STAFF RECOMMENDATION

1104 Ordway Place

February 21, 2018

Application: New construction—outbuilding/detached accessory dwelling unit; Setback determination

Figure 3: Lot in 1957, showing different outbuildings in place

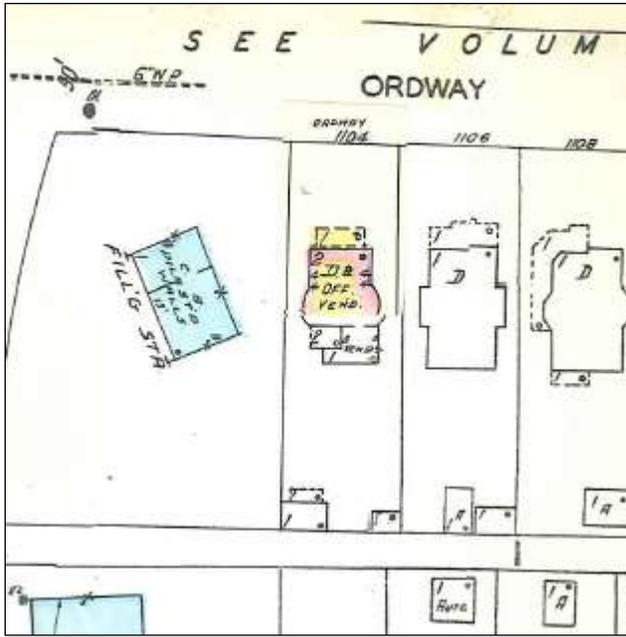
The applicant proposes to remove the existing roof and add a second story to the outbuilding. The building's date of construction is unknown, but it was built after 1957. Its form and date of construction are not indicative of the period of significance of the Lockeland Springs district. Staff finds that the structure does not contribute to the architectural and historical character and significance of the district, and that the partial demolition proposed meets Section III.B.2 for appropriate demolition and does not meet section III.B.1 for inappropriate demolition.

SITE PLAN

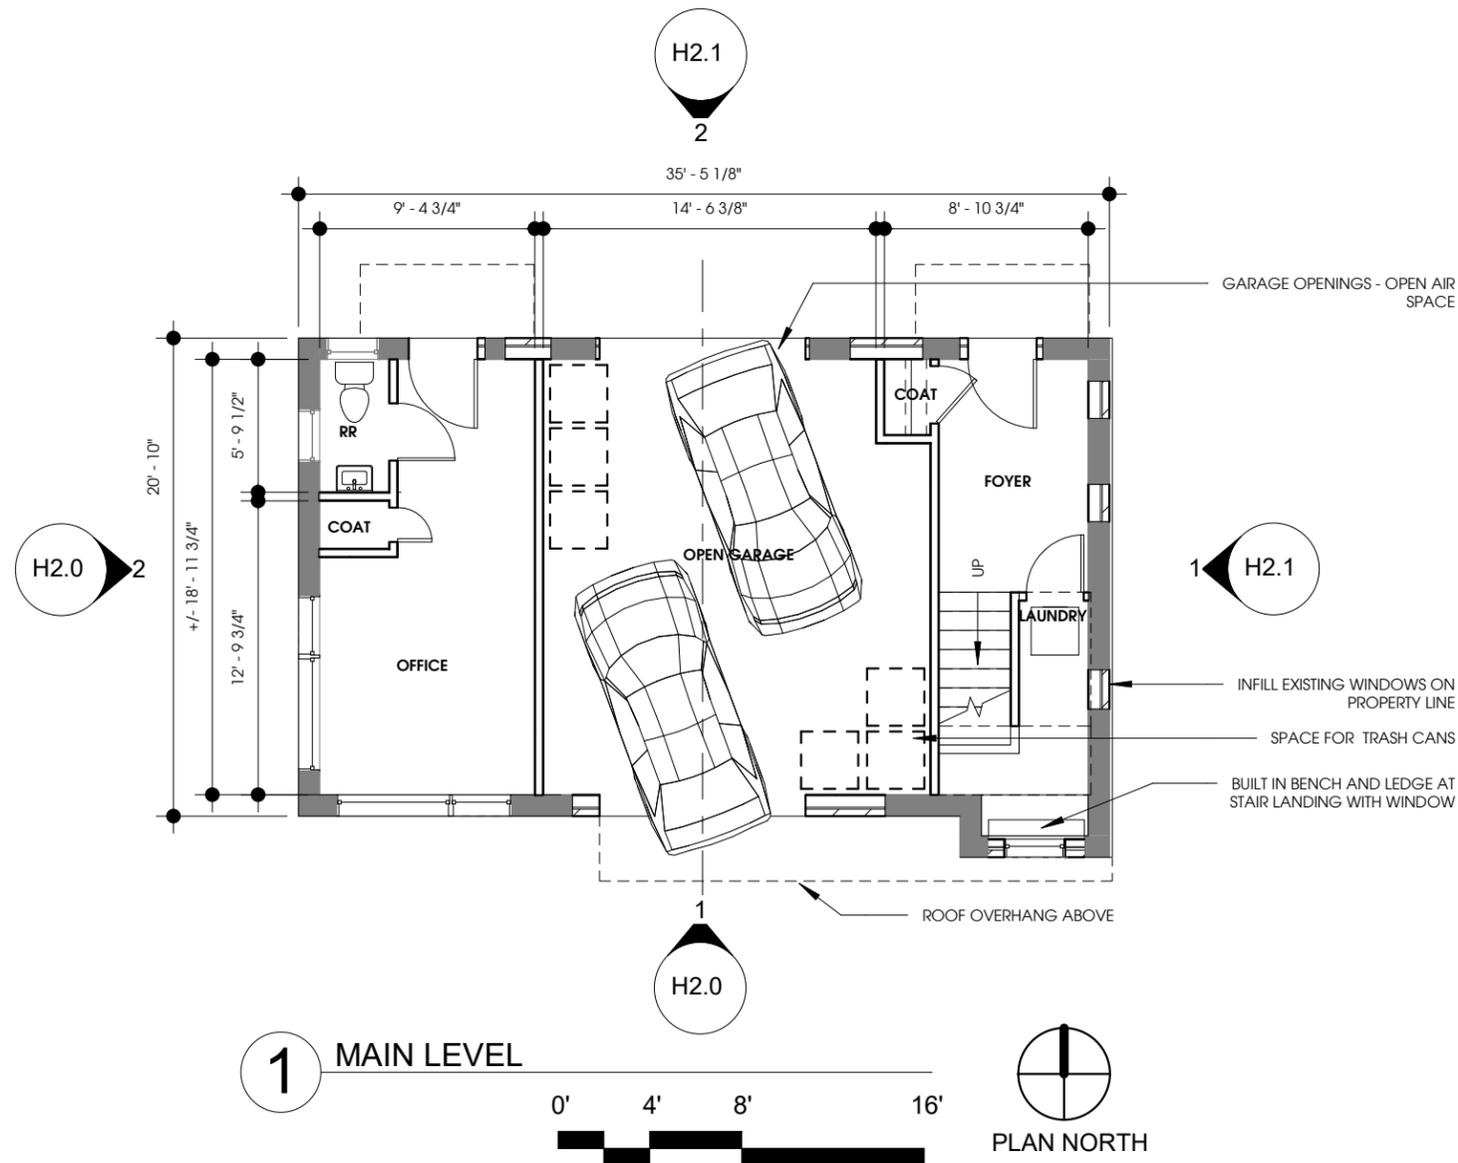
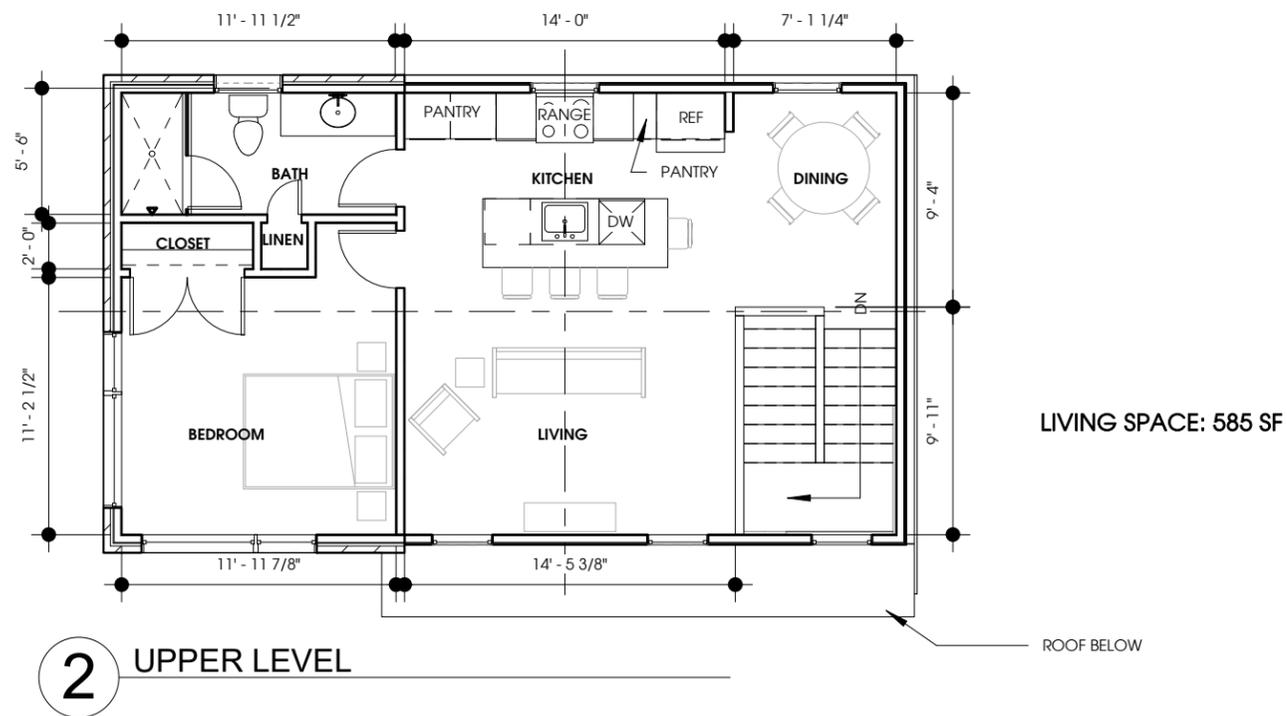
Outbuilding description:	Maximum square footage	Minimum Rear/Alley Setback	Minimum Side Setback for interior lot lines	Distance Between Principal Building and Outbuilding
Footprint greater than 700 sq. ft., Garage doors facing alley	750 sf	5'	5'	42'
Proposed	750	5'8"	10"/??	42'

The existing outbuilding is located five feet, eight inches (5' 8") from the rear property line. The side setbacks are ten inches (10") from the left side property line, and fourteen feet (14') from the right side. The Commission has regularly approved reduced rear setbacks for outbuildings, but has required the side setback to meet base zoning requirements. Last month the Commission approved a side setback of one foot (1') for an existing outbuilding. In that case there were no changes to the existing structure; the outbuilding was only one-story and four hundred and twenty square feet (420 sq. ft.) with part of that square footage being an open porch. The new outbuilding is maxing out the potential square footage and eave and ridge heights. Because of the size of the outbuilding and the significant amount of changes that may result in actually reconstructing existing conditions, staff does not find it to be appropriate to lessen the setback requirement. Staff finds that the proposal does not meet the requirements for setbacks. The project does not meet section II.B.8 of the design guidelines or 17.16.30.G. 4 of the ordinance.

Recommendation Summary: Staff recommends disapproval of the proposed detached accessory dwelling unit, finding that it fails to meet Section II.B.8 of the *Lockeland Springs-East End Neighborhood Conservation Zoning Overlay Design Guidelines* and ordinance 17.16.030.G. for setbacks.
